RE: Enterprise Recycling and Disposal Facility
Cell 16 Construction Completion Report
Response to 10/30/18 RAI
Permit No.: 177982-023-SC/T3, Pasco County
WACS No.: 87895

RE: Enterprise Recycling and Disposal Facility
Cell 16 Construction Completion Report
Revised Report per 10/30/18 FDEP Comments
Angelo's Aggregate Materials, Ltd.
FDEP Permit Nos. 177982-023-SC/T3
WACS No.: 87895
Pasco County, Florida

DRAWING: AB-03

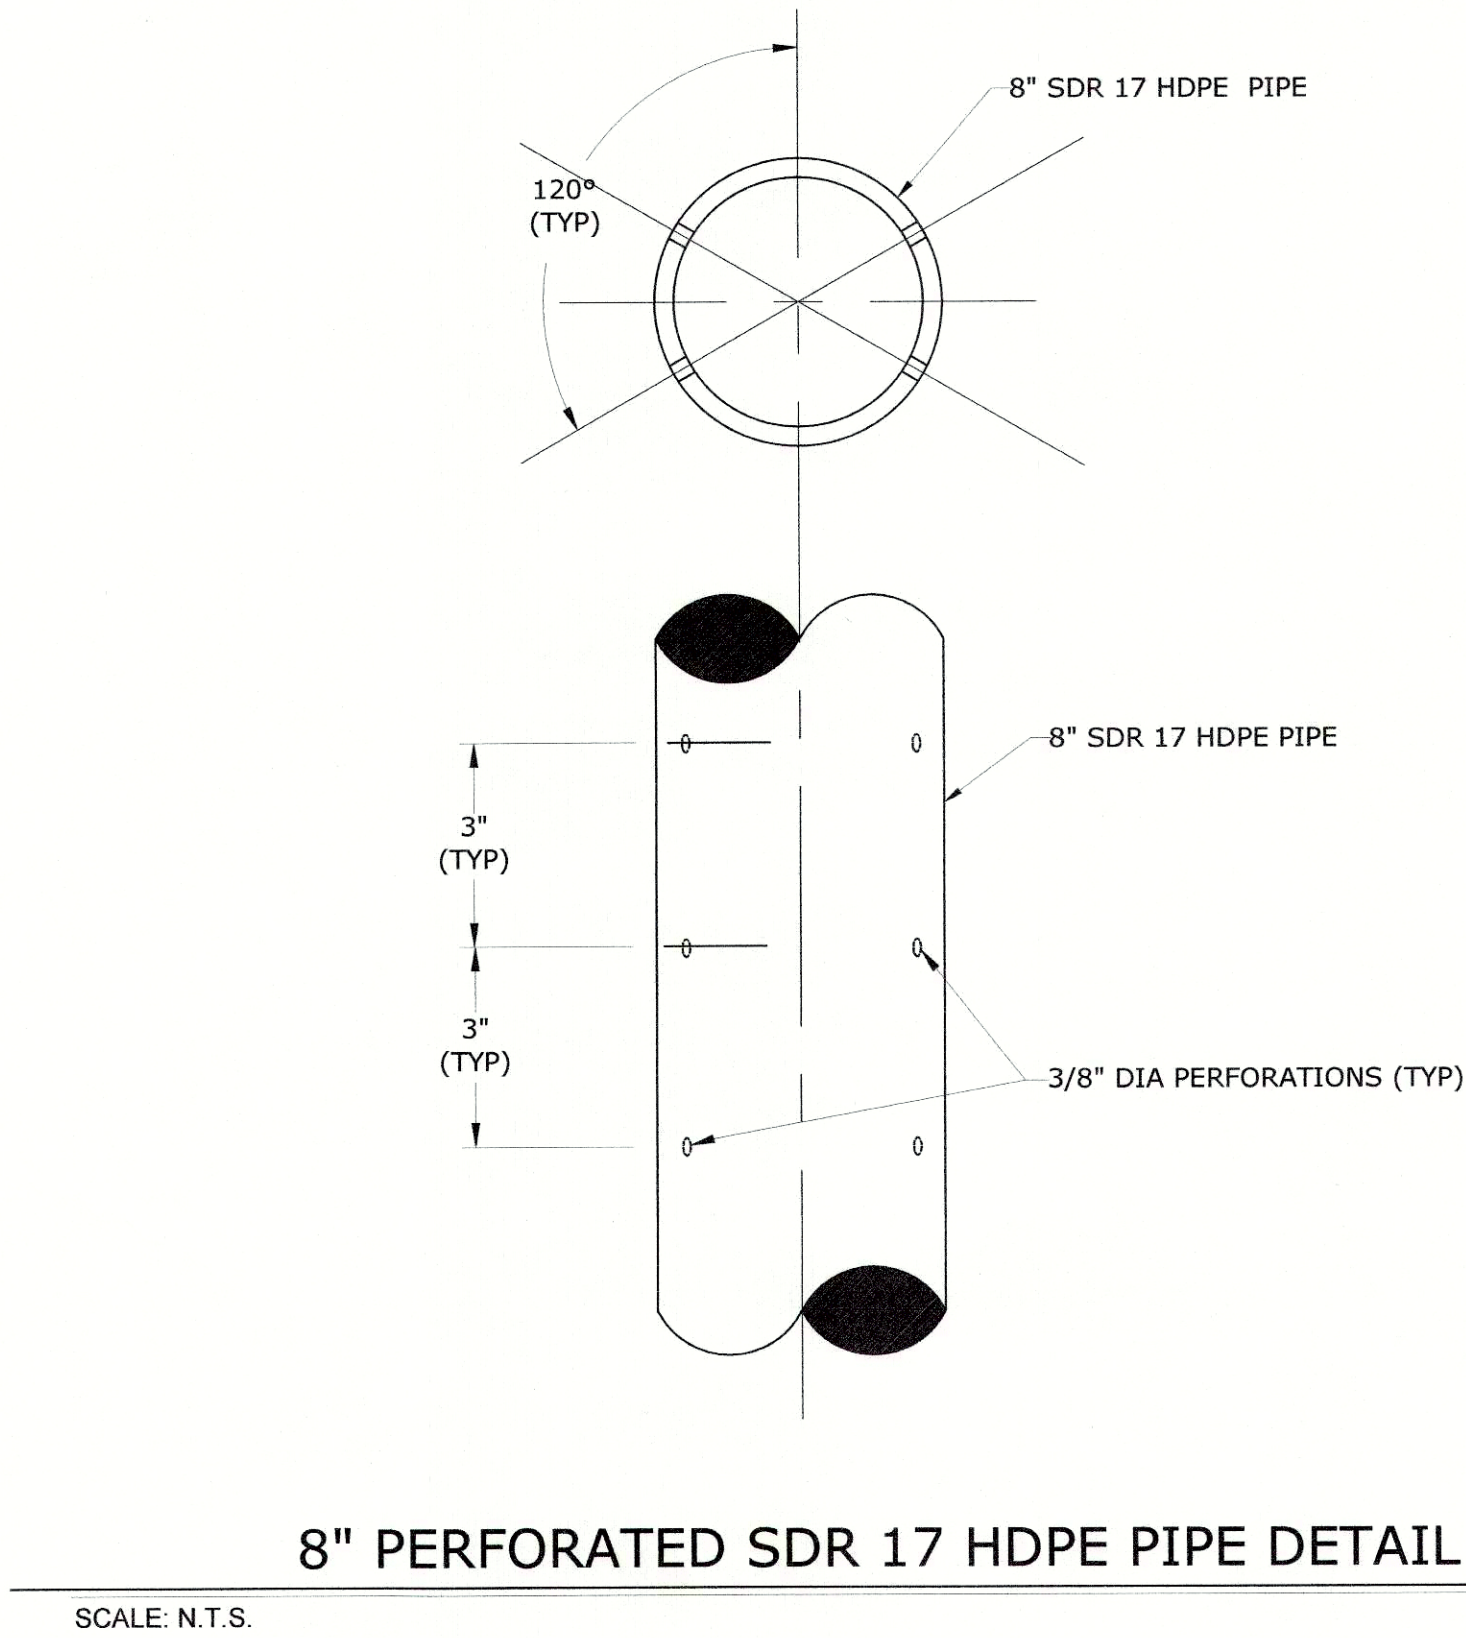
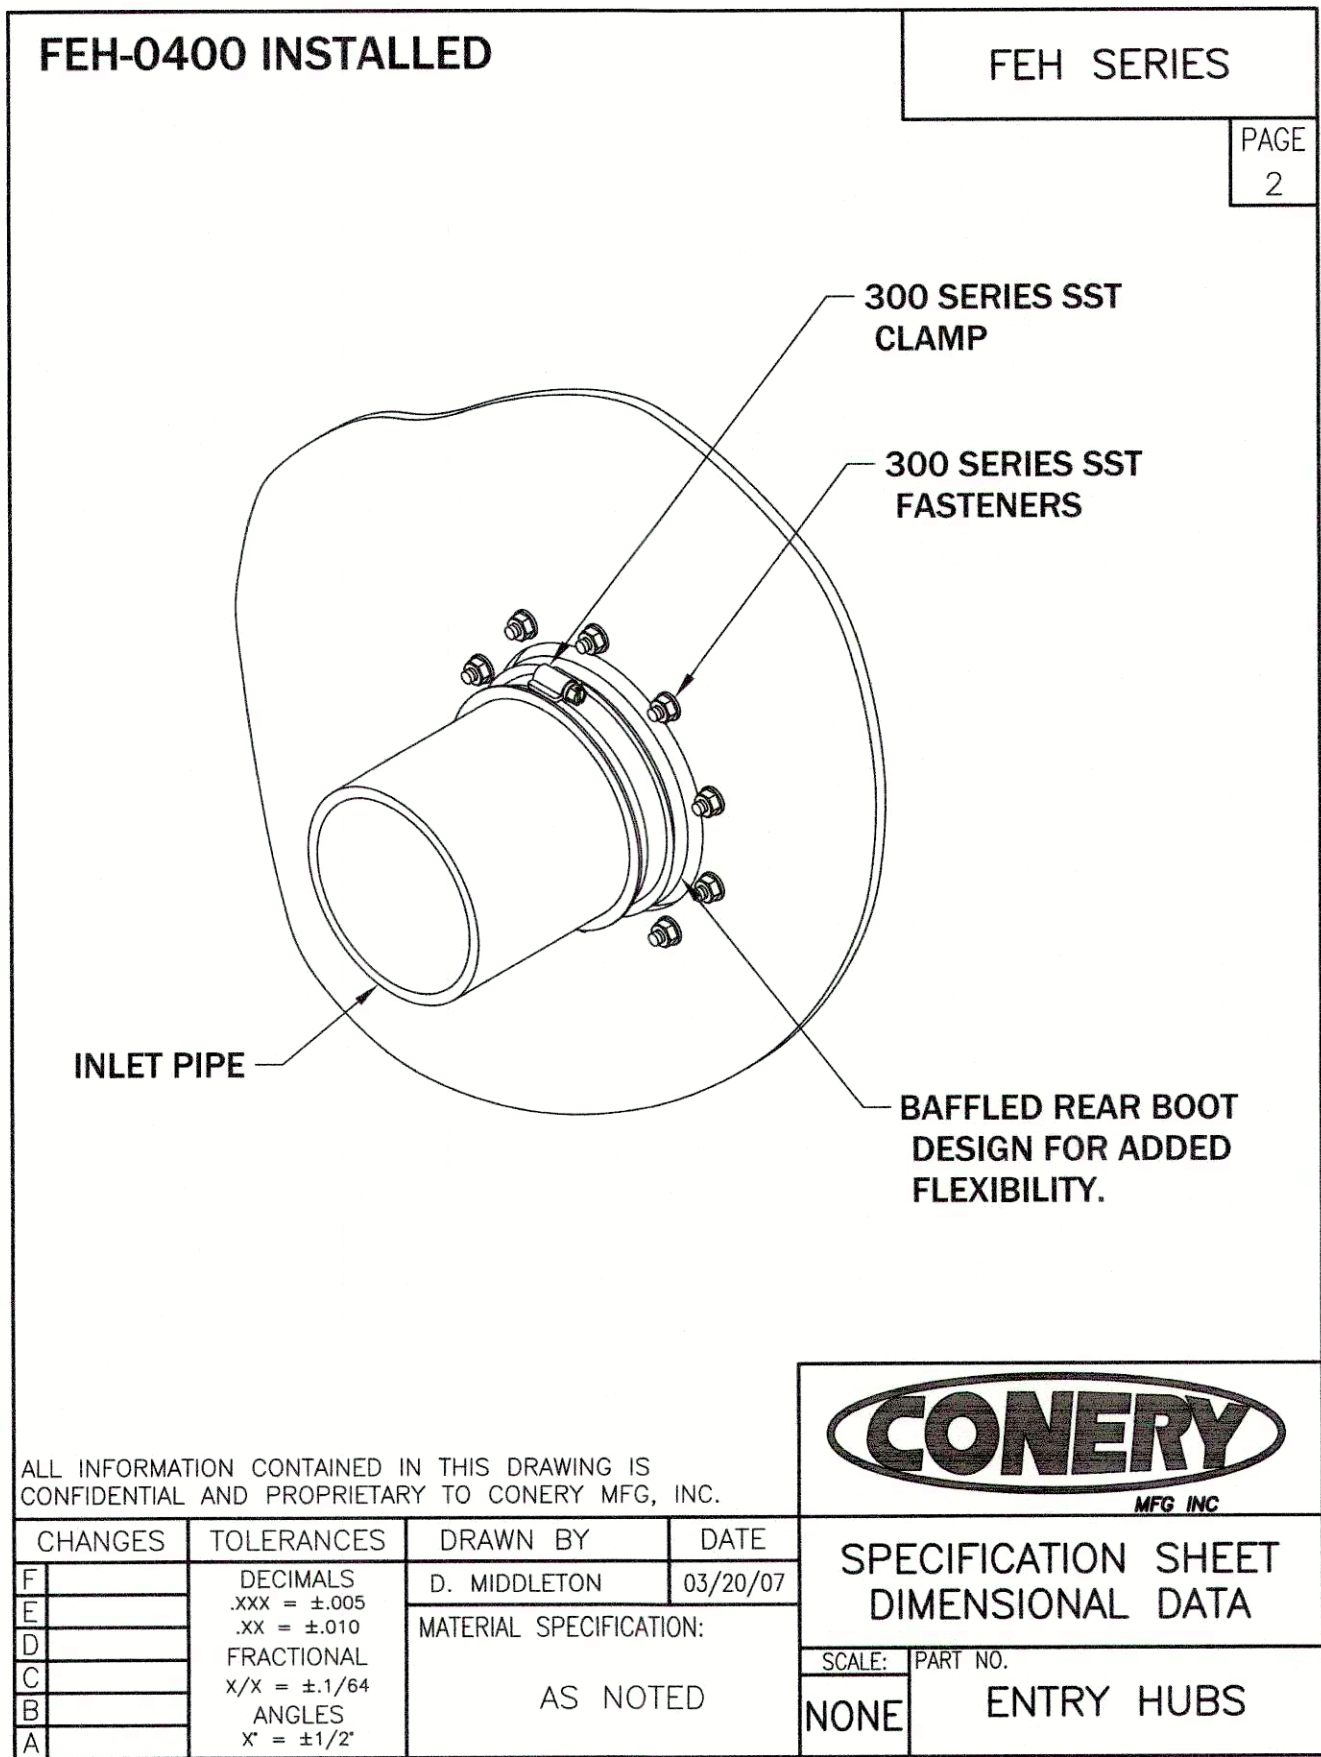
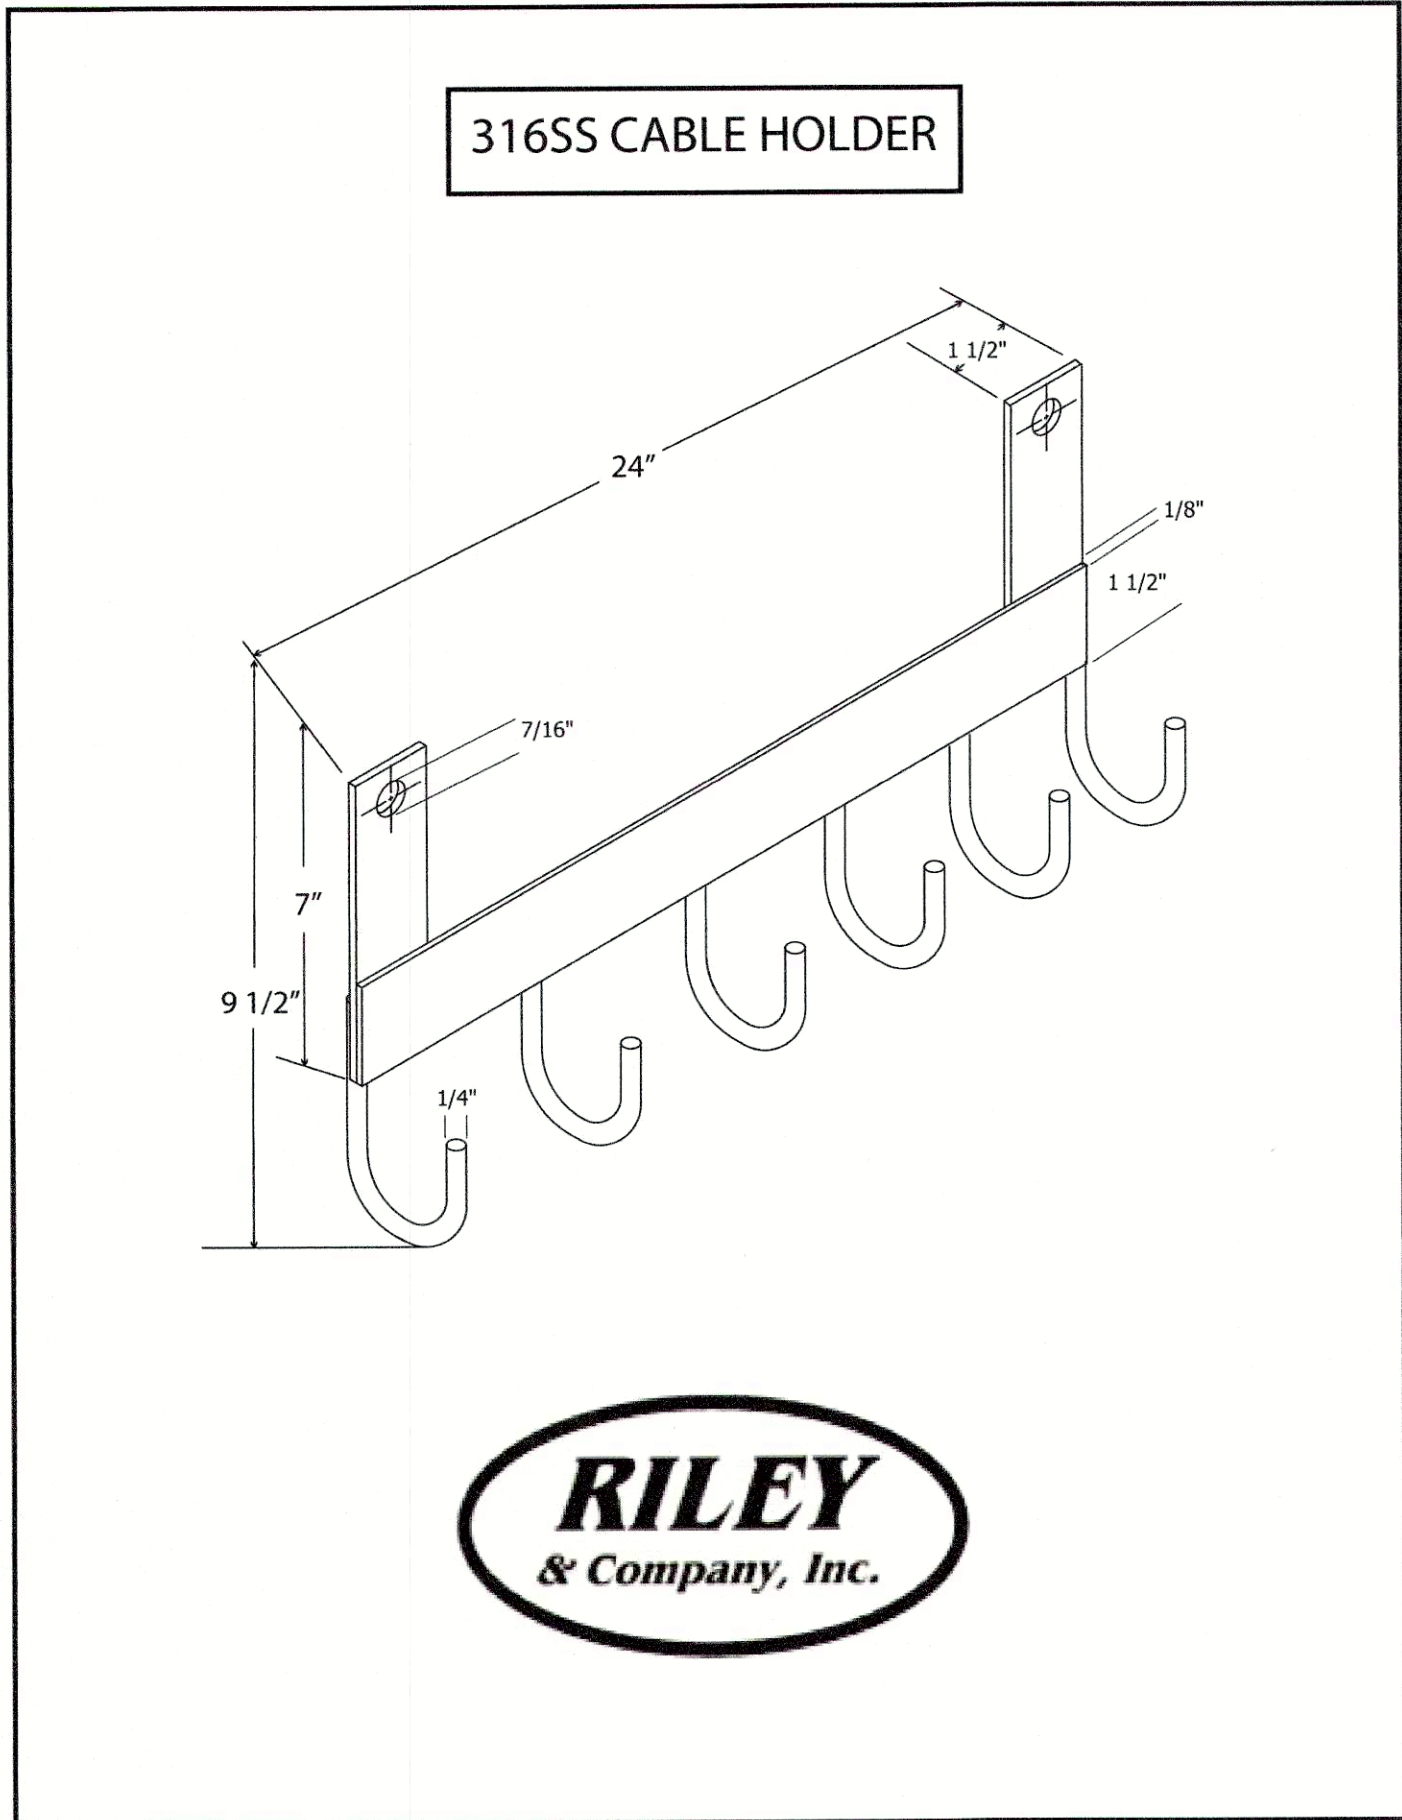
- a. The record drawing provided in Attachment B did not include as-built drawings of the constructed leachate collection trench and piping system and the constructed wet well, pump, and float control system. Please verify and provide as-built drawings of these systems.

d. The easternmost top of clay elevation in the leachate trench reported on the "Top of Clay" as-built drawing in Appendix B is 74.90 ft. NGVD. The as-built invert elevation of the leachate collection pipe at the wet well [STM-1] is reported as 74.95 ft. NGVD. Based on the apparent installation of the leachate collection pipe directly on top of the installed clay layer in the leachate trench described in Comment #5.b. and shown on the photo above, it appears that gravity flow in that section of the solid leachate pipe will flow away from the wet well. Please verify this apparent construction deviation and based on the information provided on the asbuilt drawings for the leachate collection trench and piping system provided in response to Comment 5.a. above, provide supporting justification why the leachate collection system will function properly under these conditions.

RESPONSE: Drawing C4.00 of the plan set has been included in Attachment B to show the as-built conditions of those systems.

RESPONSE: The difference between the two reported elevations is .05' or approximately ½" and is not expected to have any measurable influence on the leachate conveyance system. Using a vertical tolerance of +/- 1/16' (0.063') the elevation at the wetwell could be determined

to be as low as $74.95 - 0.063 = 74.89'$ and other elevation could be determined to be $74.90 + 0.063' = 74.96'$, showing a positive slope towards the wetwell.
